**City of Beaufort Department of Planning & Development Services  
DESIGN REVIEW BOARD (DRB) APPLICATION FORM**

**RE: PROJECT # 150027 Harris Teeter @ Lady's Island – Final DRB (resubmittal)**

**CITY OF BEAUFORT  
DESIGN REVIEW BOARD  
Staff Report  
Special Meeting of July 14, 2016**

**Case Number:** 16-01 DRB.5  
**Project:** Harris Teeter on Lady's Island  
**Property Address:** 163 & 169 Sea Island Parkway – NE Corner of Hwy 21 & Hwy 802  
**Parcel #:** R123 015 000 0587 0000; R200 015 000 0592 0000  
**Zoning:** General Commercial  
**Design District:** Lady's Island Village Center Design District  
**Type of Review:** **Final Site Plan Review – New Construction**

**Convenience Store Building:**

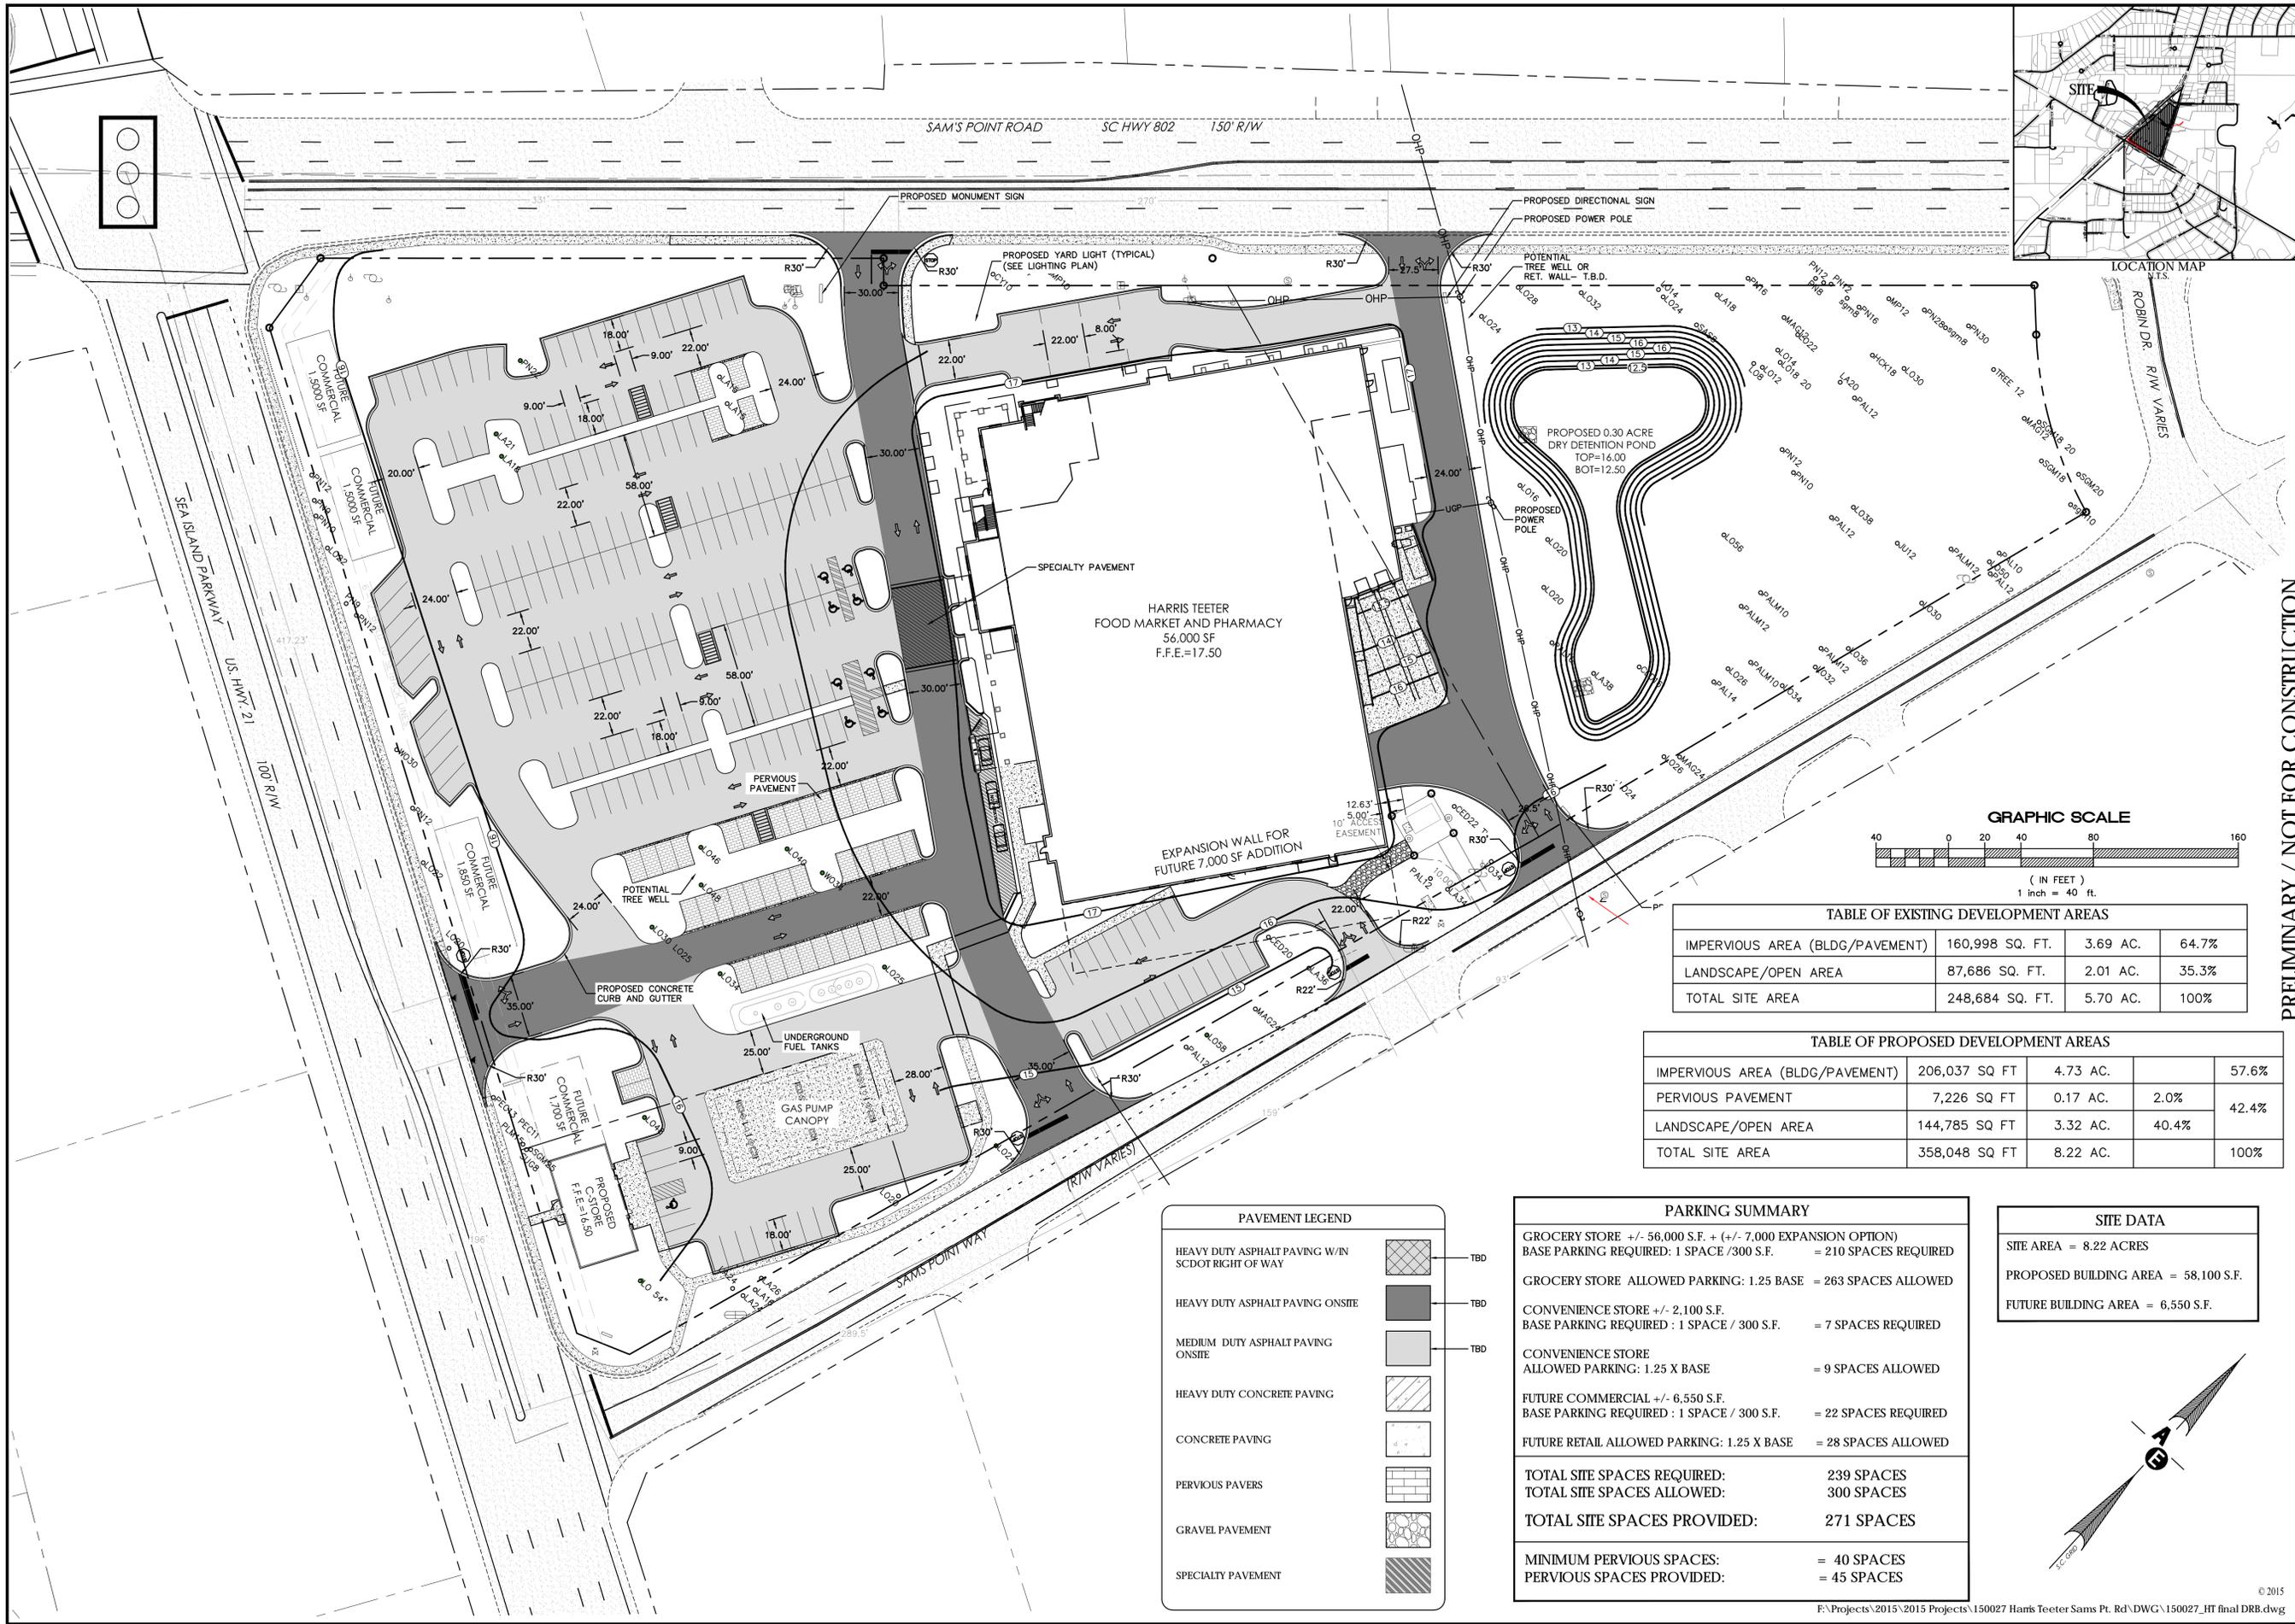
- For clarity, the architect confirmed that the “Front Elevation” is facing the gas pumps and the “Rear Elevation” is facing Sea Island Parkway.
- Please provide a floor plan for the Convenience Store. Per the architect, the windows shown on the sides and rear are to be “non vision” windows, as there are coolers directly on the interior behind the windows.

- Regarding the Sea Island Parkway elevation, this is the “Front Elevation” for the city and should be treated as such. The window pattern should be regular and utilize clear glazing. This district requires 50% minimum fenestration coverage on the ground floor; plastic glazing and use of highly reflective glass is prohibited (Section 6.6.D.9). This needs to be reconsidered on this façade.

- Similar to the comments on the Liner Building, staff recommends simplifying this building. This could be accomplished in the following ways:
  - Remove the tower

- Eliminate the larger brick modules as a base, and below the windows, and replace with a darker brick base/water table similar to the Liner buildings

- Eliminate the wood trim around the windows. All window and door openings should have proper headers (and sills for windows)
  - Consider a wider trim piece for the cornice, with the soldier course below.

- A material board and details will be required for final approval.
  - What is the design envisioned for the gas canopy? Design guidelines for Gas Stations, including canopies, are found in the Appendix of the UDO. Please provide an elevation showing the building and gas canopy from Sams Point Way in the next submission.

Staff feels that the street elevation of this building needs to be better articulated, since it faces a major right-of-way. This should be resolved and resubmitted, addressing other staff comments and board comments as well.

Harris Teeter #429  
Lady's Island, SC

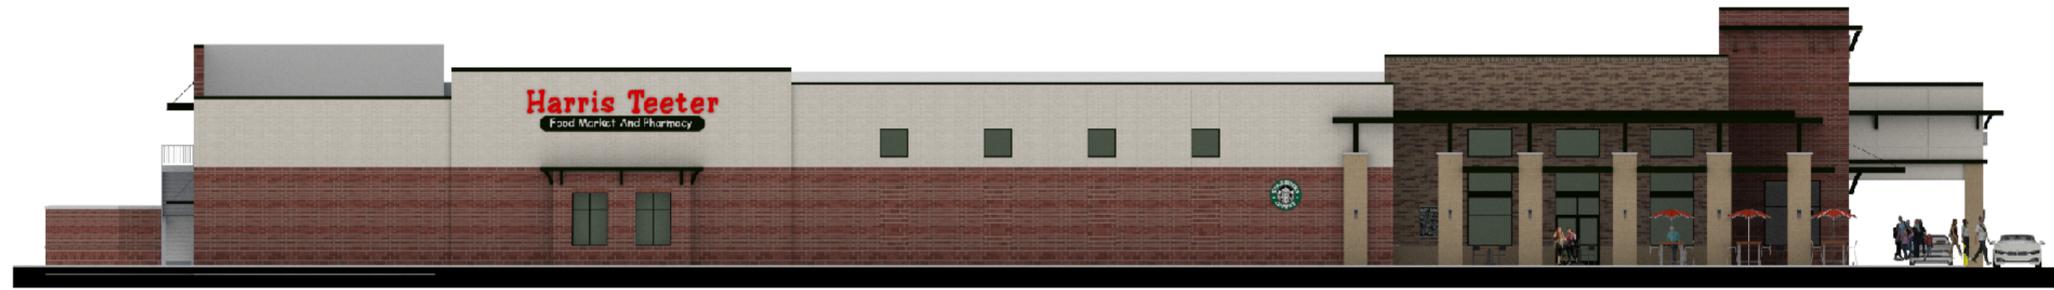
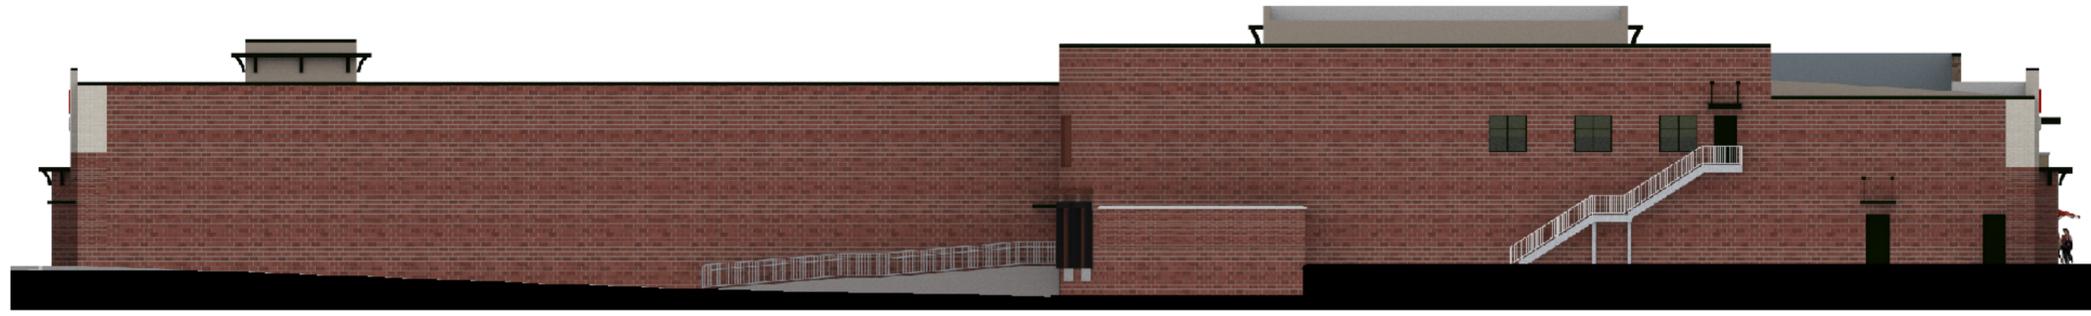
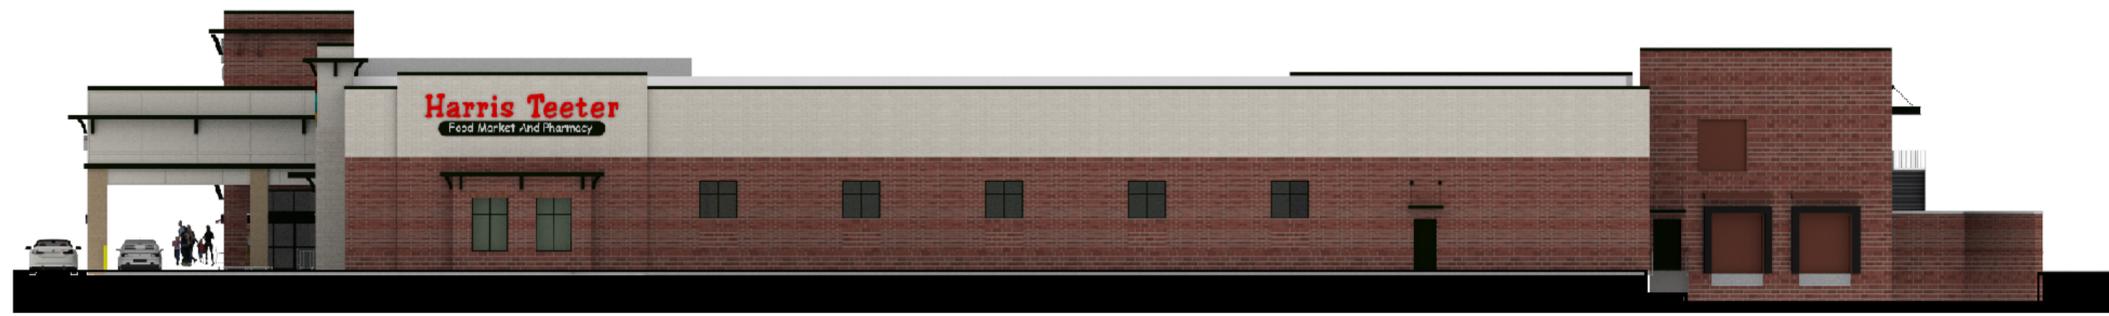
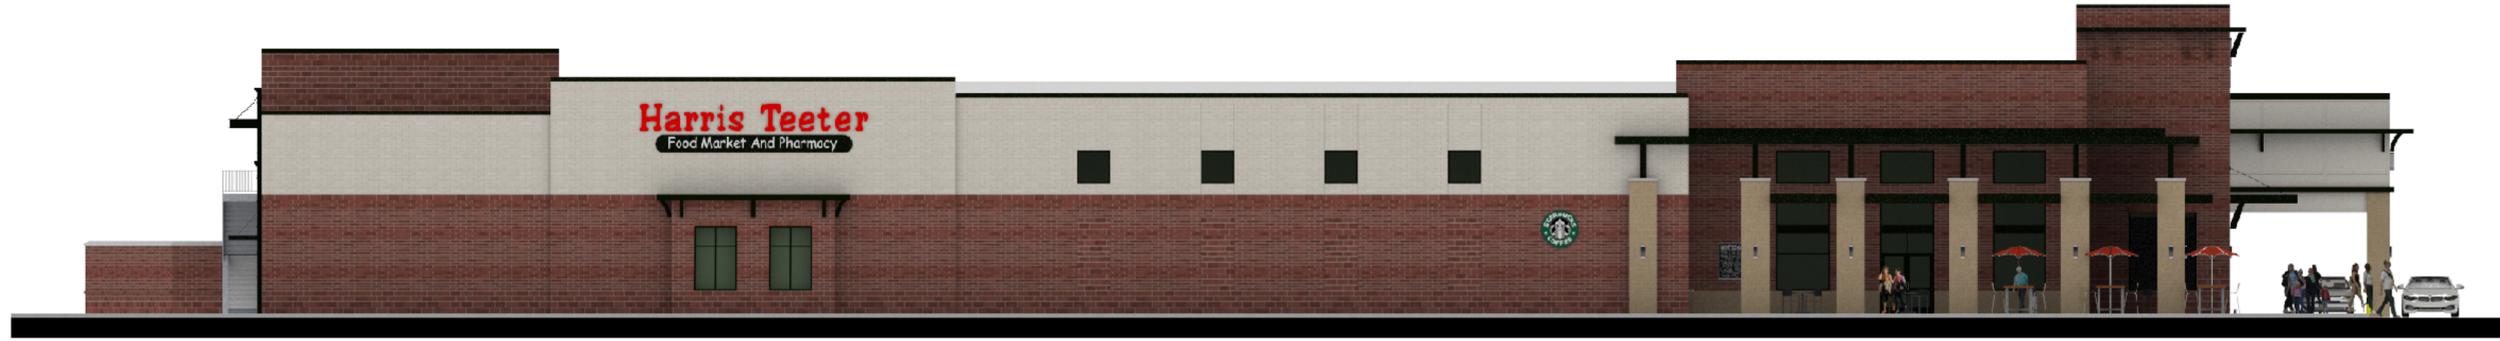
- The mezzanine element, located on the southwest corner, adjacent to Sam’s Point Road, has been eliminated. The detailing is similar, but the height in this area has been reduced.

- Long, unarticulated facades visible from public rights of way or primary vehicular entrances are not permitted.
- On Sam’s Point Road, consider introducing the shutters below the windows, in a similar location as the windows on the Sam’s Point Way elevation. The base of this elevation is still unarticulated.

- Front elevation:
  - We’ll need building details for the colonnade, typical wall sections, cornice, etc.
  - Staff prefers the elevation with the red brick at the corner.

- The transom windows in the corner should have muntions to create vertically-proportioned lite divisions
  - Staff appreciates the additional window under the colonnade area in the accounting office and store manager’s office. Further down that façade, introduce a pattern of shutters, similar to the sides, to eliminate the long, unarticulated façade. Continuing the colonnade would also be another option to alleviate this. This comment is similar to the previous submission and hasn’t been resolved.

- Sam’s Point Way elevation – staff appreciates the additional articulation in the Harris Teeter signage area. This goes towards addressing the discussion of this area from the previous DRB meeting.

- Refine/provide details of wall sections, colonnades, and cornice bracket;
- Reduce the amount of unarticulated facades using strategies listed above;
- Address any additional comments by staff and the board regarding architecture.
